Subject: Transmittal of Revision 4 to Service Bulletin V2500-ENG-73-0130.

(1) Change to Effectivity, Incorporation Amendment.

V2500-ENG-73-0130

ENGINE - FUEL AND CONTROL - FUEL SYSTEM AIR TUBES - INTRODUCTION OF REVISED PB
SENSE LINE TUBES WITH INCREASED DIAMETER

Figure 2
View AA of flange FG

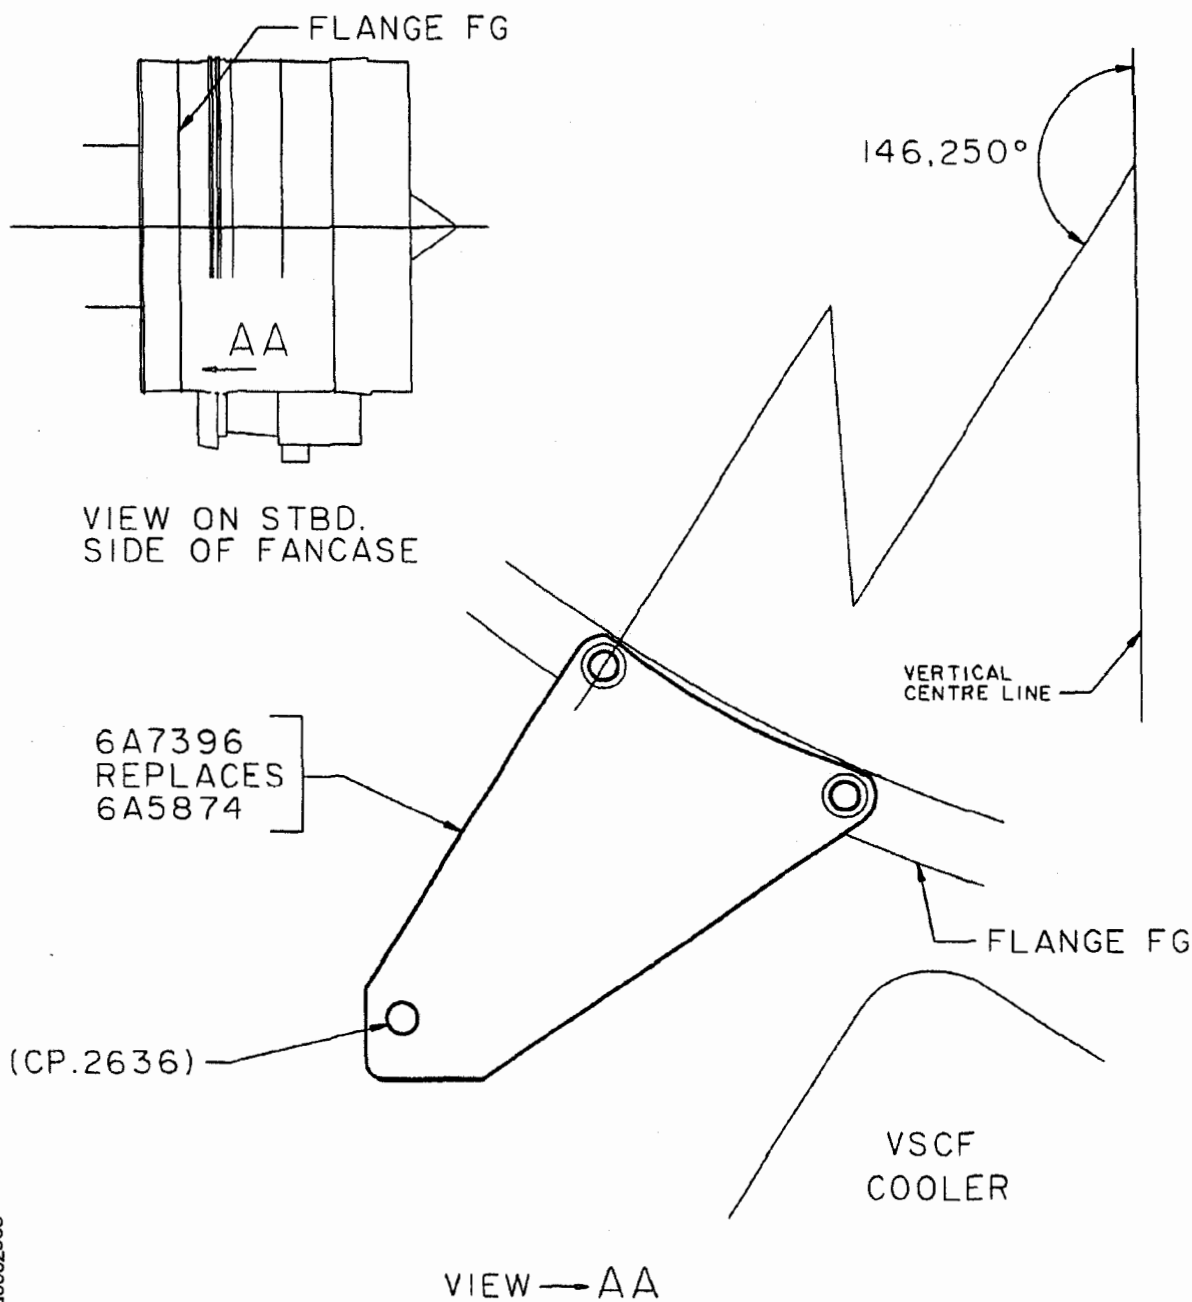
- (i) Disassemble CP2636 and discard the bolt AS20908 and the nut 4W0043.
 - (ii) Replace bracket 6A5874 with bracket 6A7396. (Refer to Figure 2). (For the correct removal/installation procedures refer to the MD-90 Engine Manual (EM), Chapter/Section 72-00-32, Removal-05 CONFIG-1 and CONFIG-2 and Installation-01 CONFIG-2 and CONFIG-3).

Figure 3
View AB of fan case

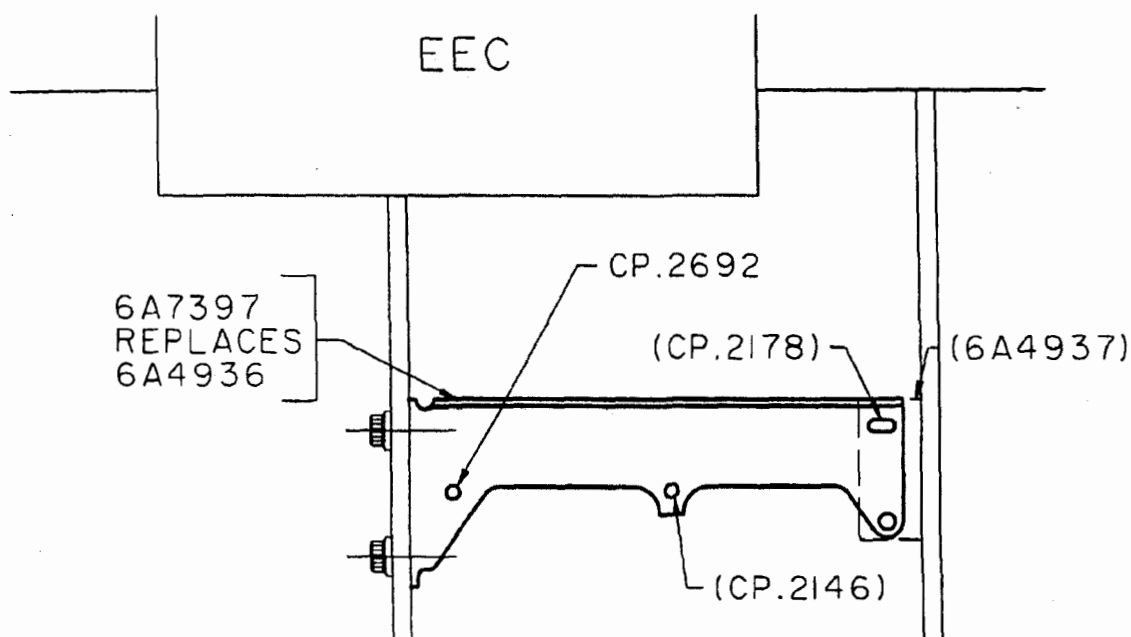
- (a) Install the union 5A8226 to the Pb port of the EEC
- (b) Replace bracket 6A4936 with bracket 6A7397. (Refer to Figure 3). (For the correct removal/installation procedures refer to the D5 Engine Manual (EM), Chapter/Section 72-00-32, Removal-05 CONFIG-1 and CONFIG-2 and Installation-01 CONFIG-2 and CONFIG-3).

- (i) Install clip AS62406 to M1550-1.
 - (ii) With bolt 4W0102 and nut 4W0001, install CP2692 to bracket 6A7397. (Refer to Figure 3).
- (4) Install tube 6A6186. (Refer to Figures 5, 6, 7, 11, 12, 34 and 35).

Figure 5
Schematic view of affected tubes and raceways - After alteration

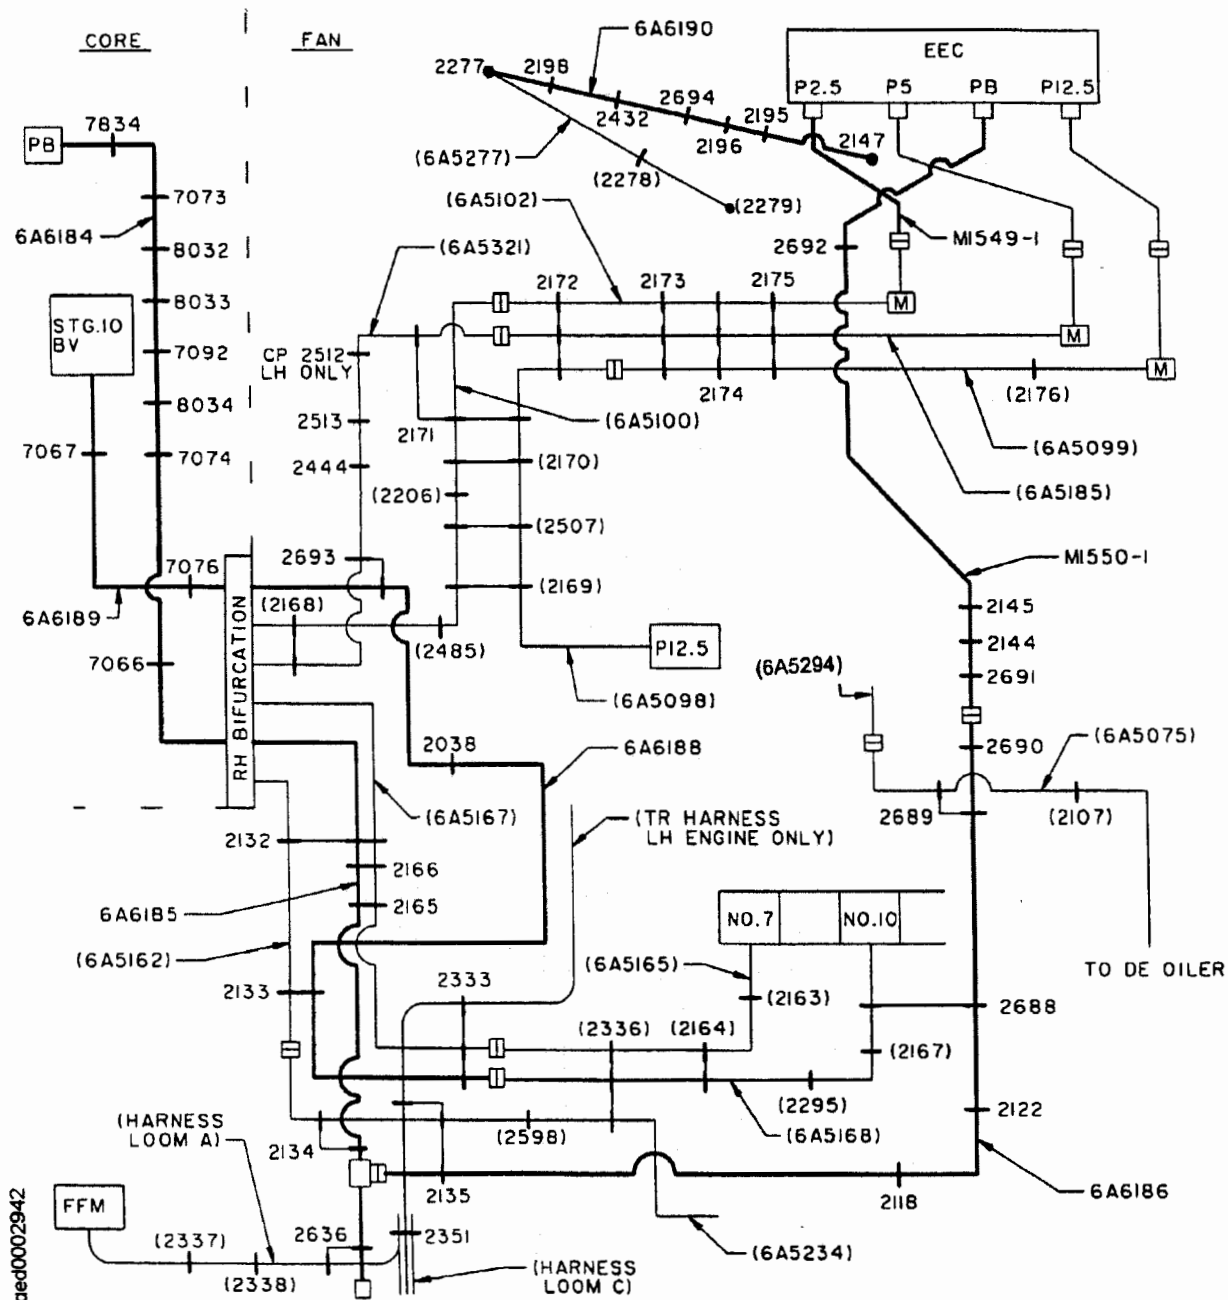
- (1) Install tube M1549-1. (Refer to Figure 5).
 - (a) Connect M1549-1 to the P2.5 connector of the EEC and to tube 6A5102.

- (c) Attach the 6A6190 to raceway 6A5277. (Refer to Figure 5).
- (3) Install tube M1550-1. (Refer to Figures 1, 3, 5, 13, 14, 35 and 36).
- (a) Install the new packing ring NAS 1595-4 to the new union 5A8226.

- (n) Safety tube 6A6186 to tube M1550-1.
- (o) Connect tube 6A5075 to tube 6A5294. (Refer to Figure 5). (For the correct installation procedures refer to the D5 Engine Manual (EM), Chapter/Section 72-00-32, Installation-03).

- (8) Install tube 6A6189 between the bifurcation panel and the Stage-10 bleed-valve. (Refer to Figure 5).
 - (a) Connect tube 6A6189 to CP7076 and CP7067.

Figure 6
Clip point 2118 - Before and after alteration

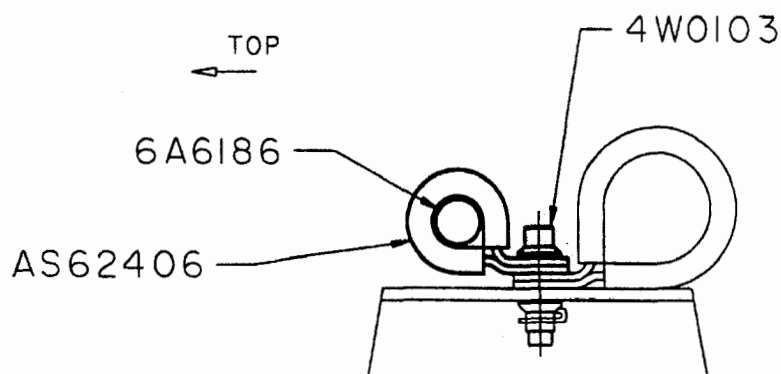
- (h) Install clip AS62404 to tube 6A6186 and then connect the clip to CP2688. (Refer to Figure 34).
- (i) Connect tube 6A6186 to CP2118 and CP2122. (Refer to Figures 6 and 7).

- (i) Disassemble CP2118 and CP2122.
 - (ii) Remove and discard bolts AS20907.
 - (iii) Install two clips AS62406 to tube 6A6186.
 - (iv) With the two bolts 4W0103 and the initial nuts, install one of the clips to CP2118 and one to CP2122

Figure 8
Clip point 2132 - Before and after alteration

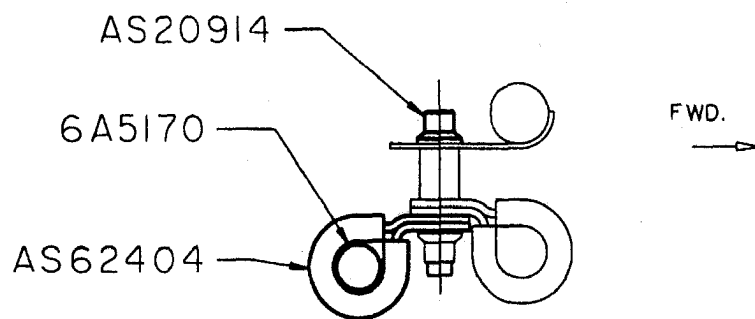
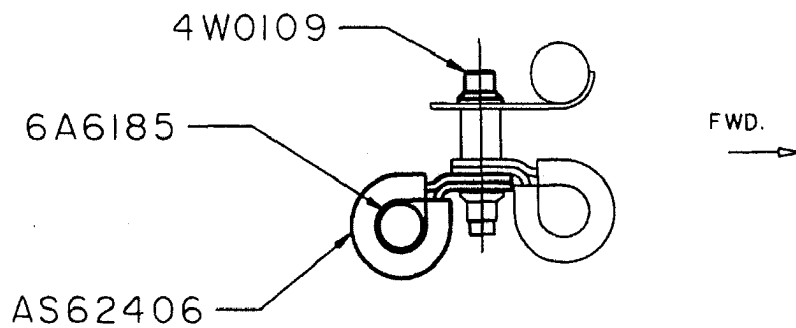
- (iii) Disassemble CP2132, then remove and discard bolt AS20914 and clip AS62404. (Refer to Figure 8).
 - (c) Disconnect tube 6A5170 from tube 6A5168 and at the Stage-10 bleed valve connector at the bifurcation panel.

- (d) Connect tube 6A6185 to CP2166. (Refer to Figure 17 and 18).
 - (i) Install clip AS62406 to tube 6A6185 and then assemble CP2166.
- (e) Connect tube 6A6185 to CP2132. (Refer to Figure 8).

Figure 9
Clip point 2133 - Before and after alteration

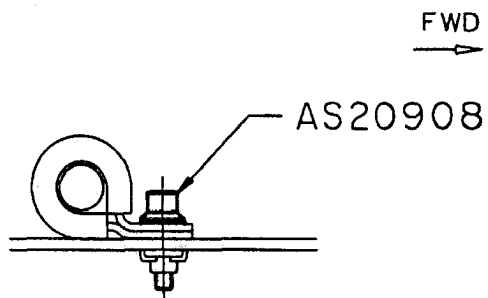
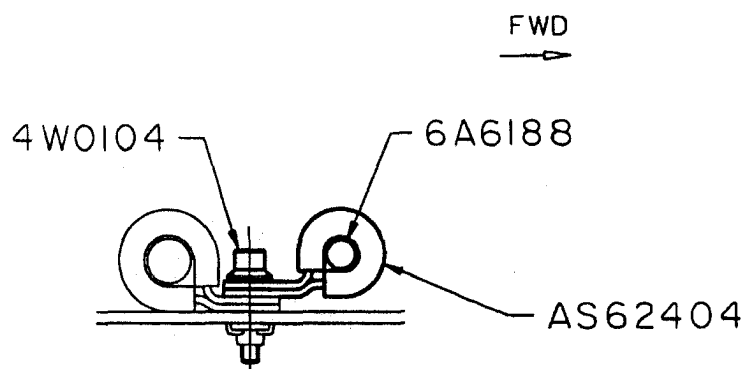
- (f) Connect tube 6A6188 to CP2133. (Refer to Figure 9).
 - (i) Remove and discard bolt AS20908.
 - (ii) Install clip AS62404 to tube 6A6188.
 - (iii) With bolt 4W0104, attach clip AS62404 to CP2133.

Figure 10
Clip point 2134 - Before and after alteration

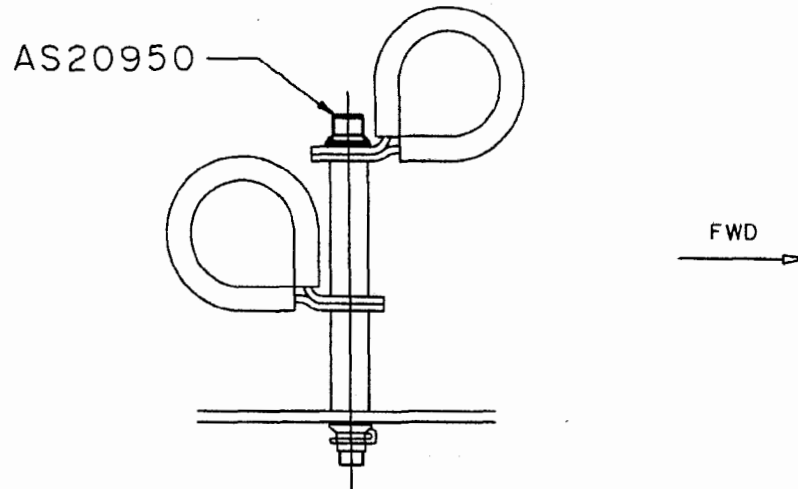
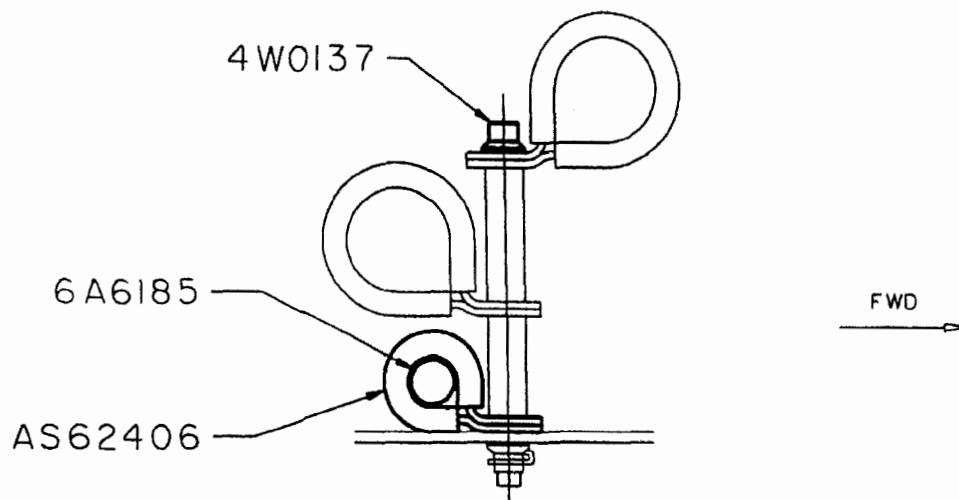
- (b) Connect tube 6A6185 to CP2134. (Refer to Figure 10).
 - (i) Disassemble CP2134 and discard the bolt AS20950.
 - (ii) Install clip AS62406 to tube 6A6185

Figure 11
Clip point 2135L - Before and after alteration

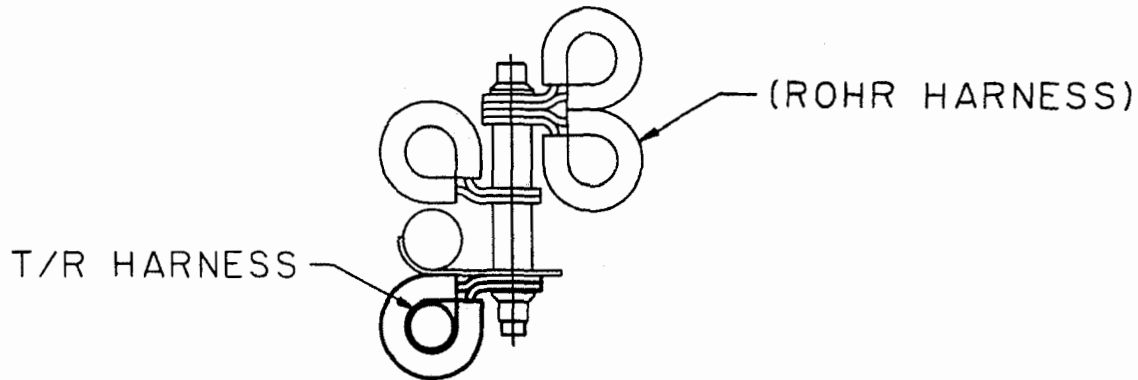
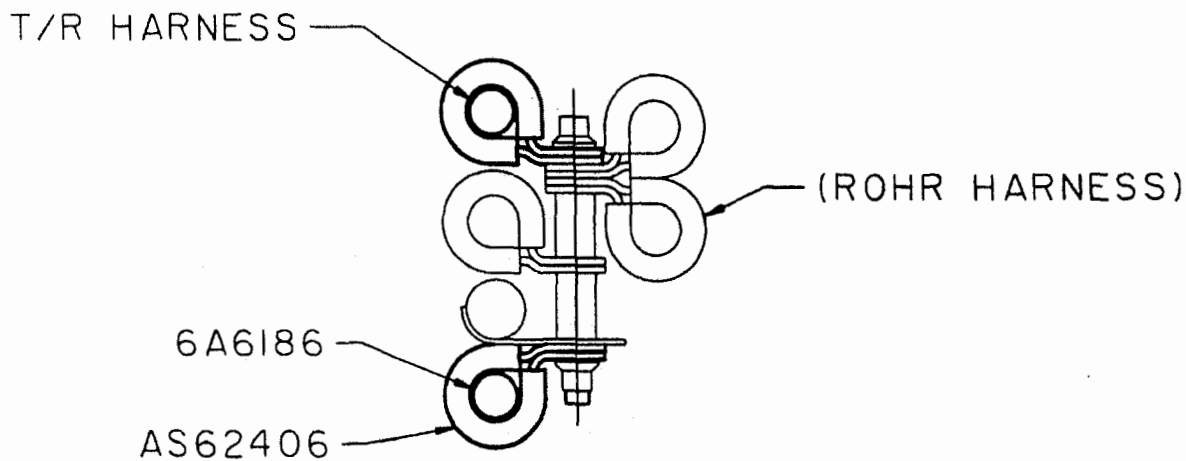
- (j) For the left engine only, connect tube 6A6186 to CP2135L. (Refer to Figure 11).
 - (i) Disassemble CP2135L
 - (ii) Move the clip for the thrust reverser harness from the bottom of the clip-stack to the top.

- (iii) Install clip AS62406 to tube 6A6186 and then connect it to CP2135L.
 - (iv) With the initial bolt, spacers and nut, assemble CP2135L.
- (k) For the right engine only, connect tube 6A6186 to CP2135R. (Refer to Figure 12).

Figure 13
Clip point 2144 - Before and after alteration

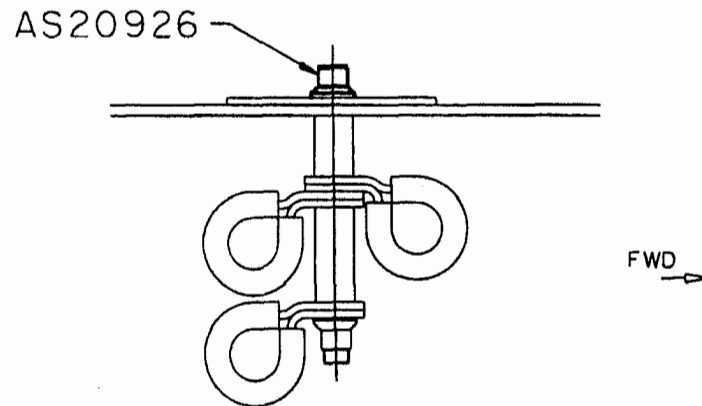
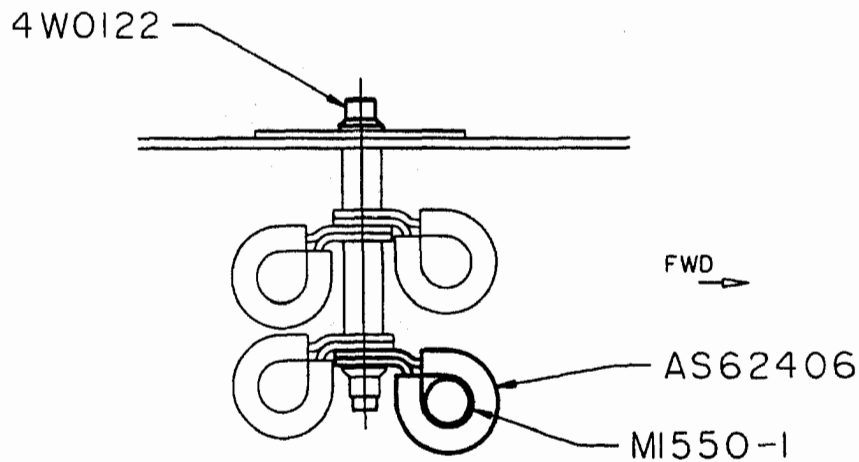
- (c) Connect M1550-1 to the Pb union (5A8226) of the EEC.
- (d) Connect M1550-1 to CP2144. (Refer to Figure 13).
- (i) Disassemble CP2144. (If necessary, disconnect the electrical connector R5-8002 for Looms A and B adjacent to CP 2144 and then disassemble the clip points sufficiently to get access to CP2144).

- (ii) Remove and discard the bolt AS20926.
- (iii) Install clip AS62406 to M1550-1 and then to CP2144.
- (iv) With bolt 4W0122 and the initial spacers and nut, install CP2144 to the bracket.

Figure 14
Clip point 2145 - Before and after alteration

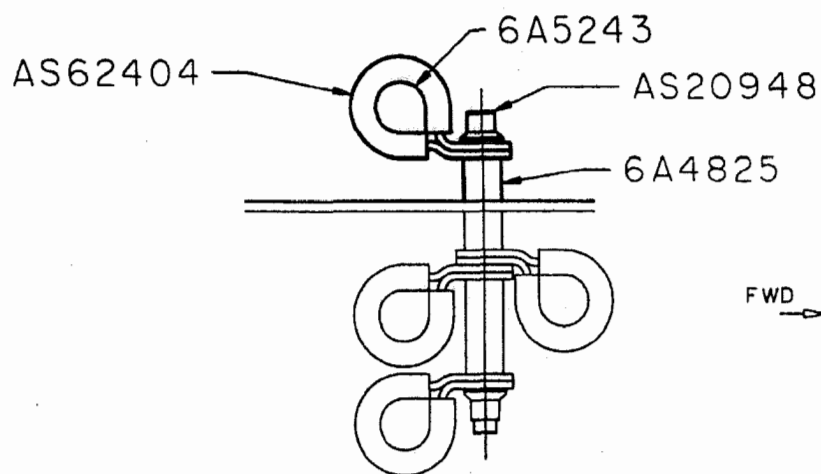
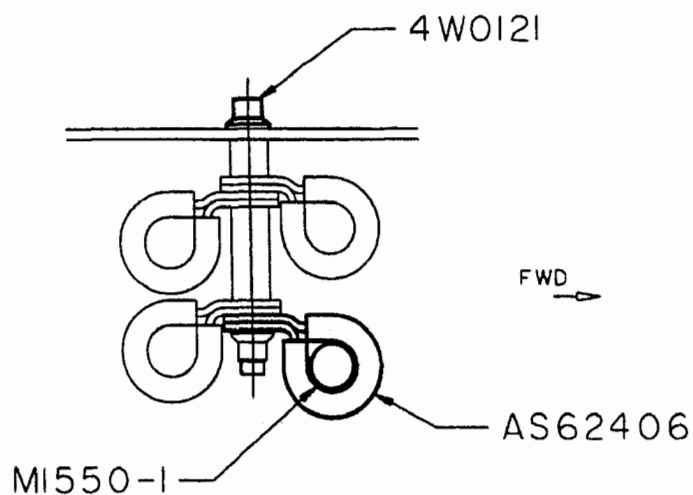
- (4) Remove tube assembly 6A5243. (Refer to Figures 4, 14, 21, 22 and 23).
 - (a) Disconnect CP2145 from tube 6A5243. (Refer to Figure 14).
 - (i) Disassemble CP2145.

- (ii) Remove and discard bolt AS20948, clip AS62404 and spacer 6A4825.
 - (b) Disconnect CP2175 from tube 6A5243. (Refer to Figure 23).
 - (i) Disassemble CP2175.

- (v) If necessary, connect the electrical connector and assemble any of the clip points removed at step (d) (i).
- (e) Connect M1550-1 to CP2145. (Refer to Figure 14).

Figure 15
Clip point 2147 - Before and after alteration

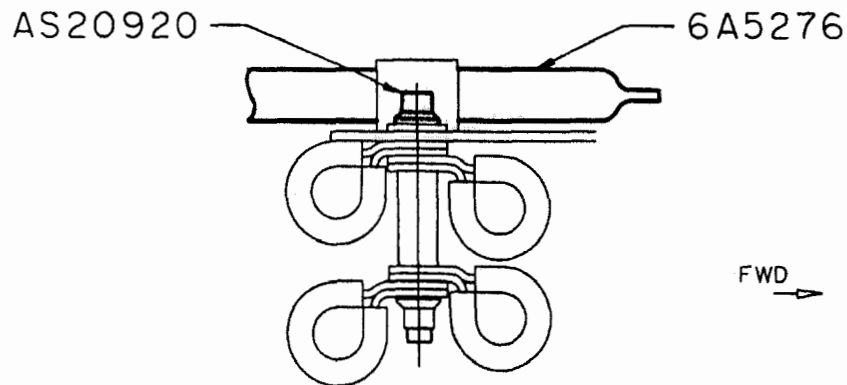
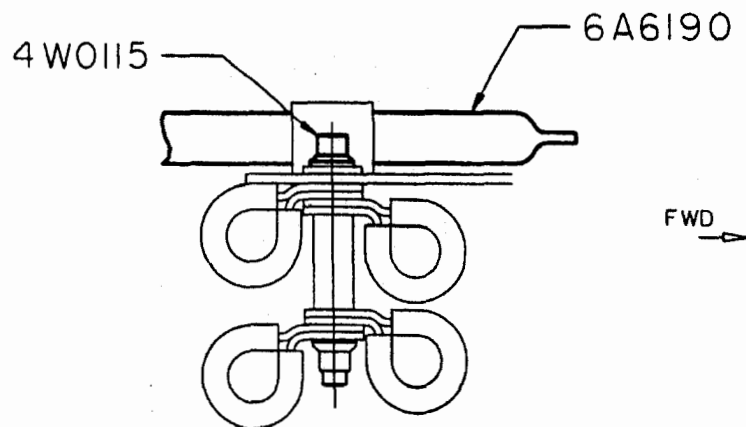
- (i) Remove and discard the bolt AS20920 from CP2147. (Refer to Figure 15).
 - (ii) Remove and discard the bolts AS20908 from CP2196 and CP2198. (Refer to Figures 24 and 25).

- (i) With the bolt 4W0115 and the initial nut, install CP2147. (Refer to Figure 15).
- (ii) With the bolt 4W0118, the spacer UP10482 and the initial nut, install CP2195. (Refer to Figure 24).

Figure 16
Clip point 2165 - Before and after alteration

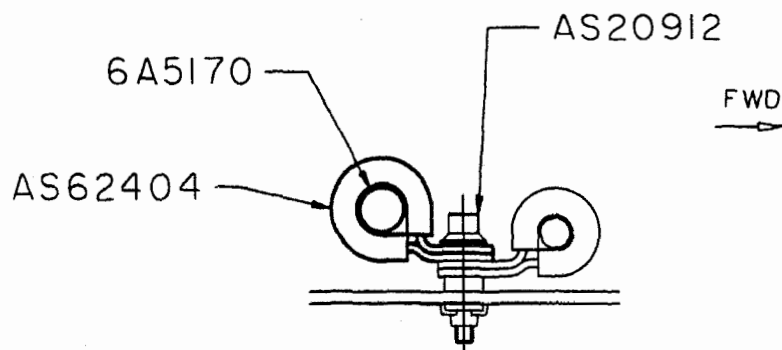
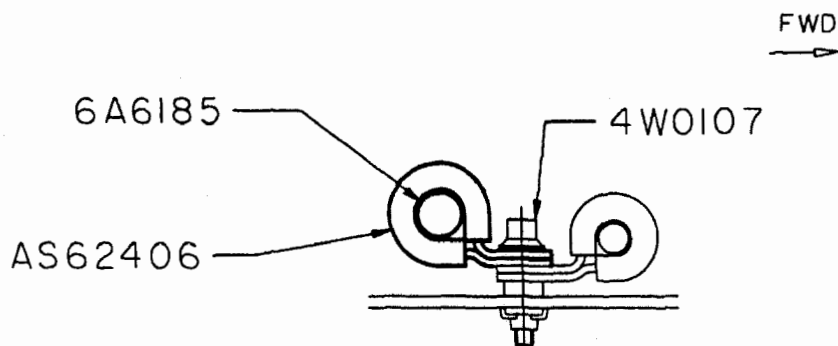
- (i) Disassemble CP2165 and remove and discard bolt AS20912 and clip AS62404. (Refer to Figure 16).
 - (ii) Disassemble CP2166 and remove and discard bolt 4W0117, spacer UP10480 and clip AS62404. (Refer to Figure 17 and 18).

- (c) Connect tube 6A6185 to CP2165. (Refer to Figure 16).
 - (i) Install clip AS62406 to tube 6A6185 and then with the new bolt 4W0107, assemble CP2165.
